Access Compliance Report Public Rights-of-Way (Curb Ramps)

Intersection ID: 32279 Main Street: AUBURN_TOP_LN Cross Street: CAPRICORN_LN Location: SW

ADA ID: 3EAD638A2259 Ramp Type: Combination1Diag Initial Pass/Fail: Fail Overall Compliance: No Severity Score: 0

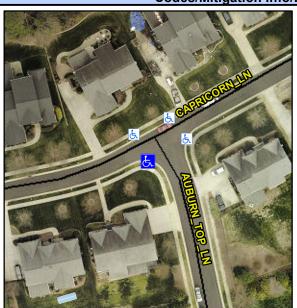
LT RP < 5%

Not Found, R304.5.1, R304.5.3, R304.3.2

Remove & Replace Curb Ramp With Two New Directional Ramps or Equivalent.
